Re: Oconee Nuclear Station  
Docket Nos. 50-269-270, -287

In response to your letter of January 21, 1974, please find attached a description and safety evaluation of modifications of the Oconee Nuclear Station 230 KV switchyard breaker failure relay circuitry.

DUKE POWER COMPANY  
OCONEE NUCLEAR STATION  
SAFETY EVALUATION  
MODIFICATIONS TO THE 230 kV SWITCHYARD

Development OCONEE NUCLEAR STATION See Dwg. \_\_\_\_\_ File No. \_\_\_\_\_  
Subject PROPOSED BREAKER FAILURE RELAY DESIGN Sheet No. 1 of 1  
By \_\_\_\_\_ Date 4/23/74

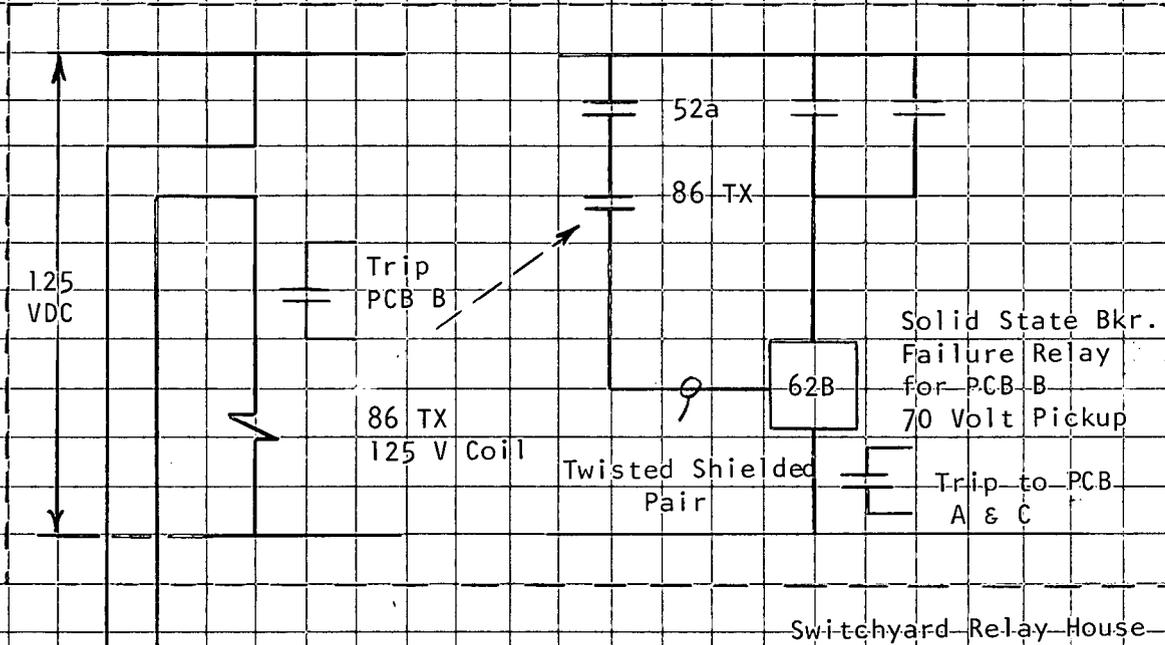
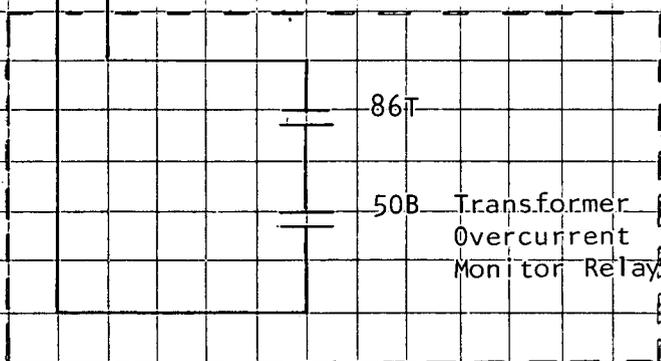
The following revisions to the affected circuit breaker failure relay circuits will be made to prevent actuation by spurious induced signals:

- (1) The five transformer lockout relay contact circuits from station to switchyard will be run in separate cables.
- (2) Additional ground cables will be installed in trenches between the station and the switchyard for increased electrostatic shielding.
- (3) Interposing relays with 125V DC coils will be installed in these circuits in the switchyard relay house.
- (4) Connecting circuitry from interposing relays to breaker failure relays will be by shielded twisted pair cable.
- (5) The pickup setpoint of the breaker failure relays will be increased from the present value of 15 volts to over 70 volts.
- (6) Overcurrent monitor relays will be installed to monitor the startup transformers for low side faults, and to supervise the interposing relay circuit.

In addition to these six corrective measures, two modifications will be made to assure greater operational reliability. The red and yellow bus differential relaying will be placed on separate panels and supplied by separate DC power sources. The 24V DC trip interposing relays utilized in the individual circuit breaker control circuits will be replaced with relays having 125 V coils.

The separation of the five transformer lockout contact circuits into five individual cables will prevent any induced currents in one cable from affecting more than one breaker failure relay initiating circuit. The additional ground cables installed in the trenches between the station and the switchyard will

provide increased electrostatic shielding and will protect the cables from external influences. The installation of the interposing relays with 125V DC coils in the circuit requires that any induced currents produce a voltage of such magnitude that its probability of occurrence is negligible. In the event that such an induced current did occur, it could not operate the interposing relay in the startup transformer lockout circuits unless the transformer overcurrent monitor relay, which supervises the circuit, had operated. In addition, contacts, from the interposing relay will be used to trip the associated circuit breakers. Since this circuit is supervised by PCB breaker auxiliary contacts, this precludes misoperation of the interposing relay which could, heretofore, initiate a false breaker failure signal. To preclude operation of the breaker failure relay by induced current in the circuit from the interposing relay, shielded twisted pair cable is utilized, and the breaker failure relay pick-up setpoint will be increased to a value of approximately 70 volts.
